City of Richmond
Urban Development Division

**Report to
Development Permit Panel**

File: DP 04-270828

Re: **Application by Patrick Cotter Architect Inc. for a Development Permit at
7520 Gilbert Road**

SITE PLAN

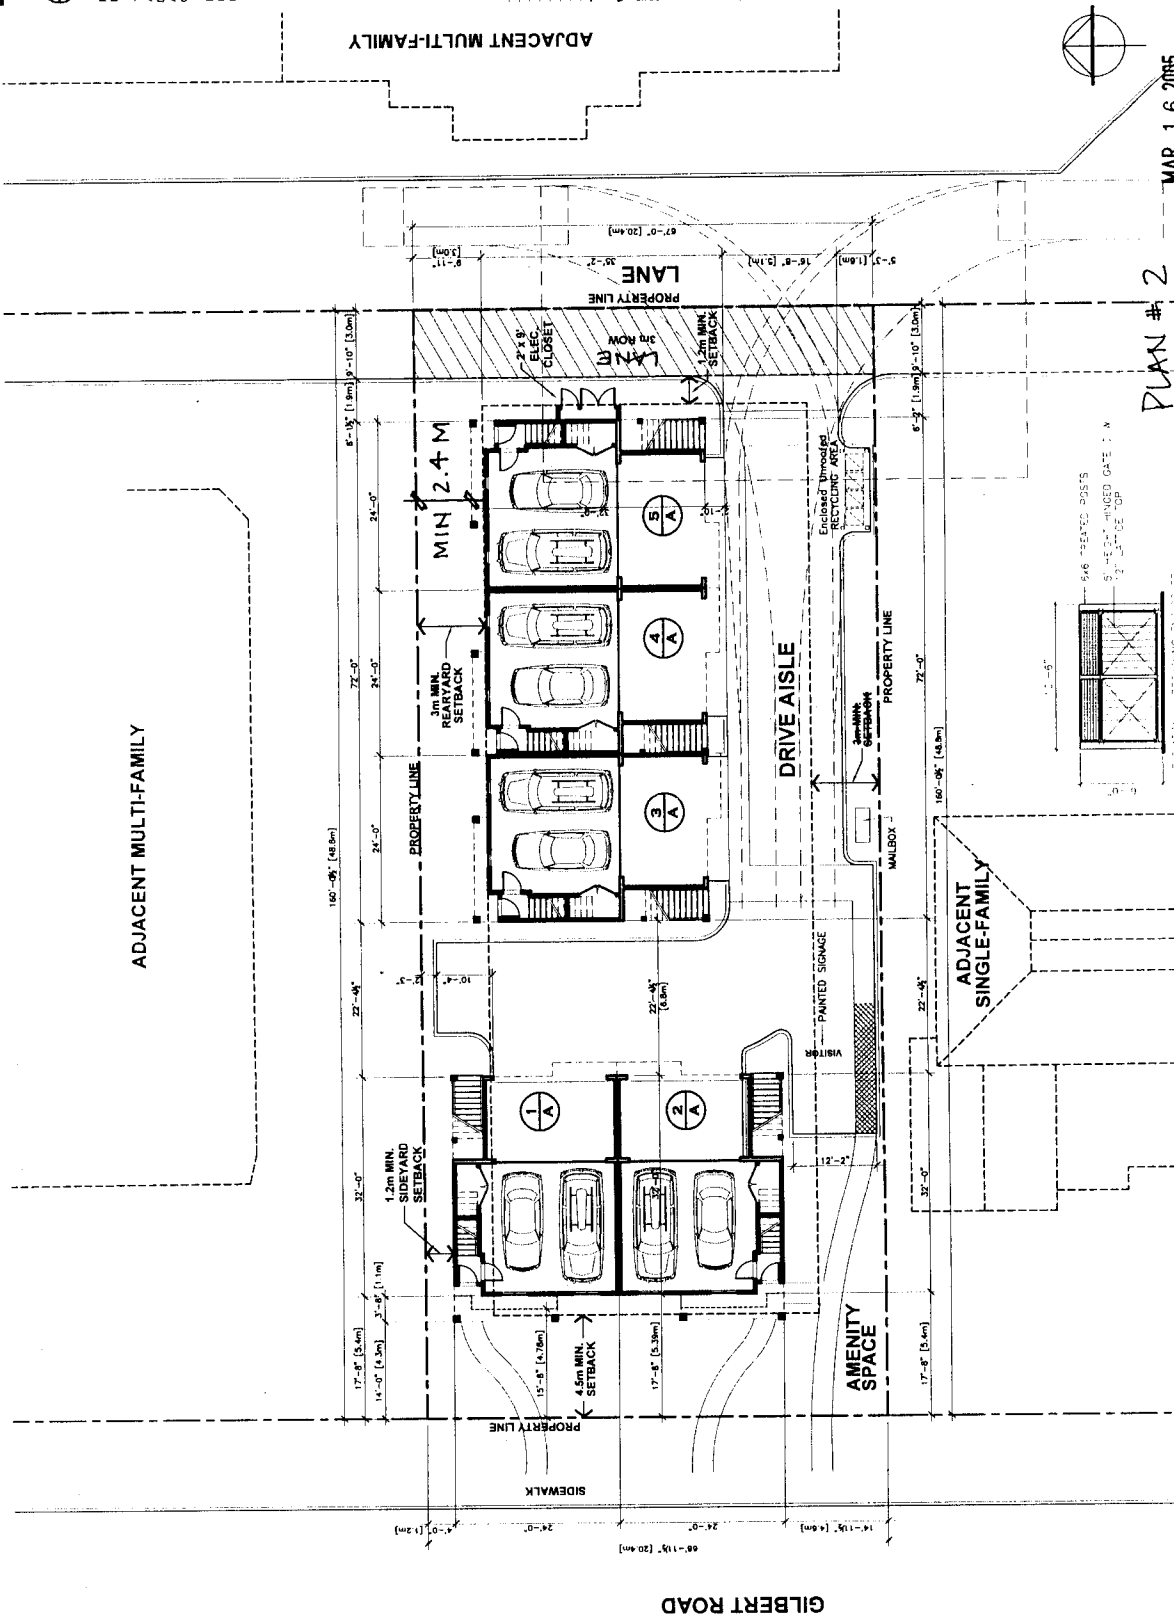
- some of the existing trees on the south side could be saved by rearranging the garbage area, etc. Increased planting could occur on the north side of 2 units which would provide a buffer to the north property line. Shifting the building somewhat would allow an increase to the buffer. Use larger type trees. Might be an opportunity for street trees. An opportunity exists for decorative paving throughout. The blank walls that face public areas could be improved by more buffer planting and taller trees.

- (iii) improving the landscape buffer to the north – *incorporated*;

- Landscape buffers and 1.8 m wood privacy fencing are located along the north and south property lines which separate the development from the adjacent multi-family development and single-family home.

LANDSCAPE PLAN

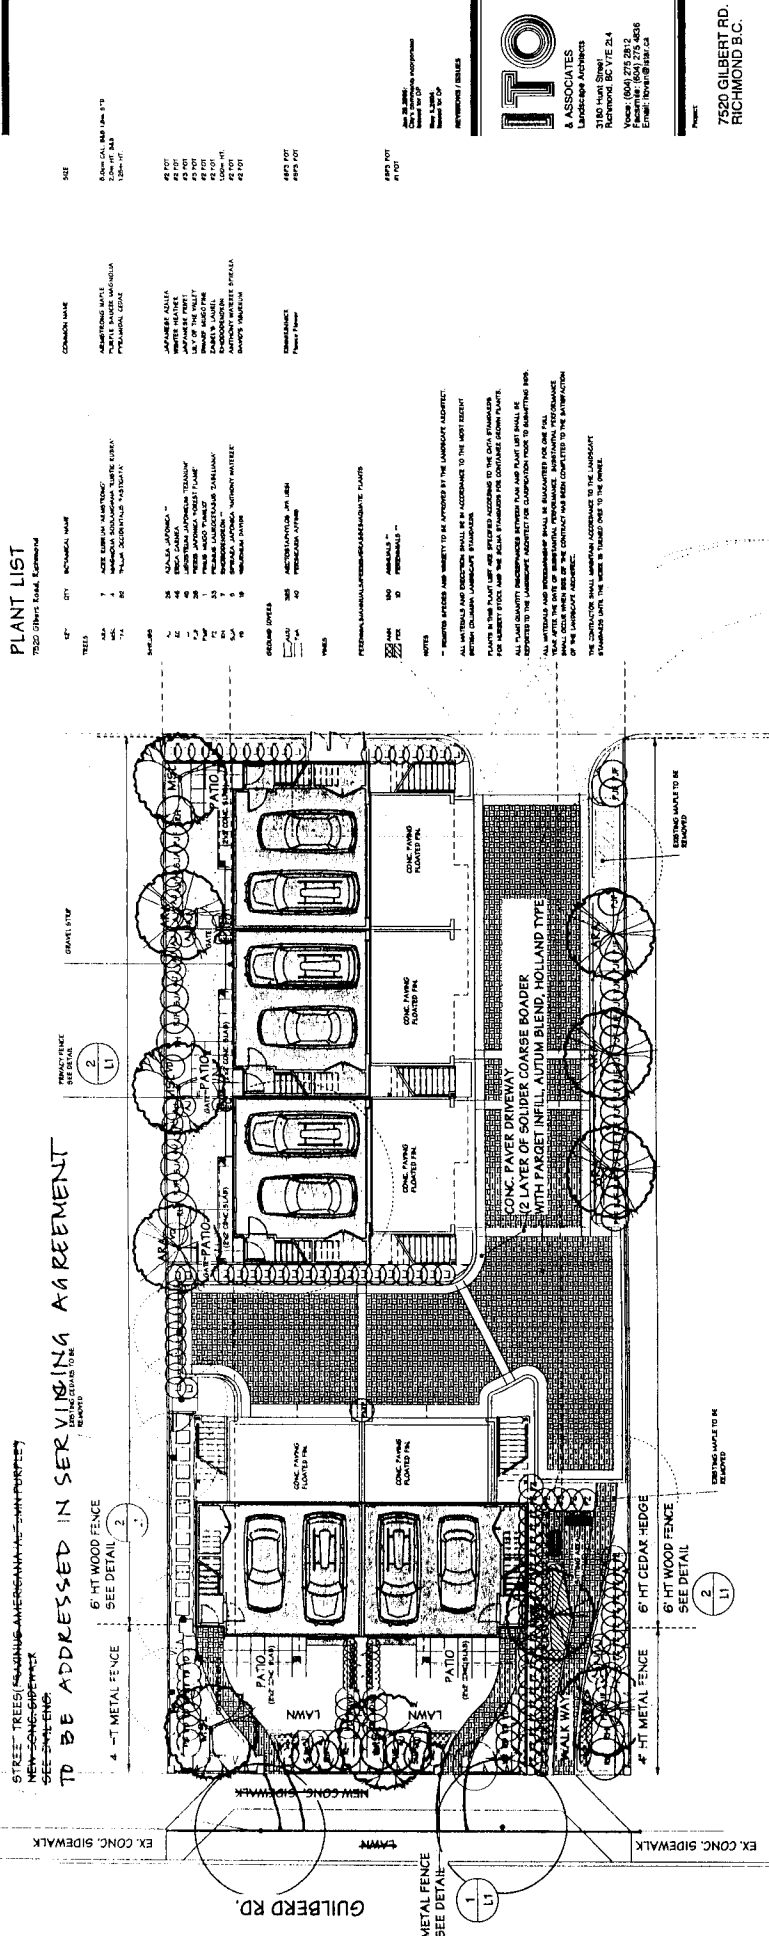
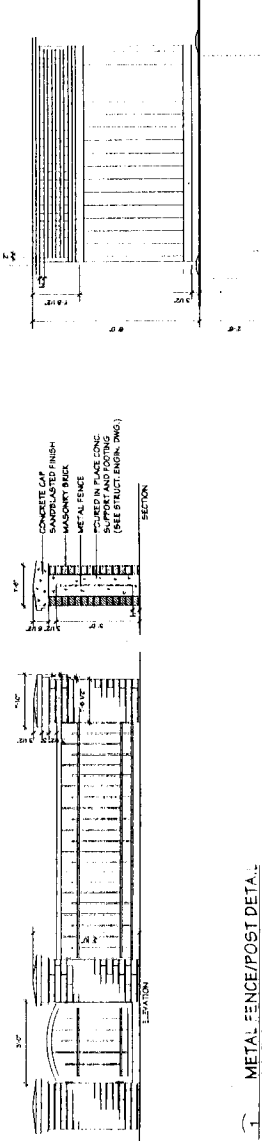
- (i) tree retention or a replacement tree strategy;

- (iv) incorporating larger trees – *incorporated*;

- (v) the possibility of incorporating street trees;

As retention is not feasible with the proposed site plan, a tree replacement strategy has been provided. A registered arborist has deemed that the only two trees in fair condition need to be removed due to conflict with the manoeuvring aisle. The remaining six existing trees were recommended for removal due to poor to hazardous health.

Will be arranged through the Servicing Agreement.

TO BE ADDRESSED IN SERVINGING AGREEMENT
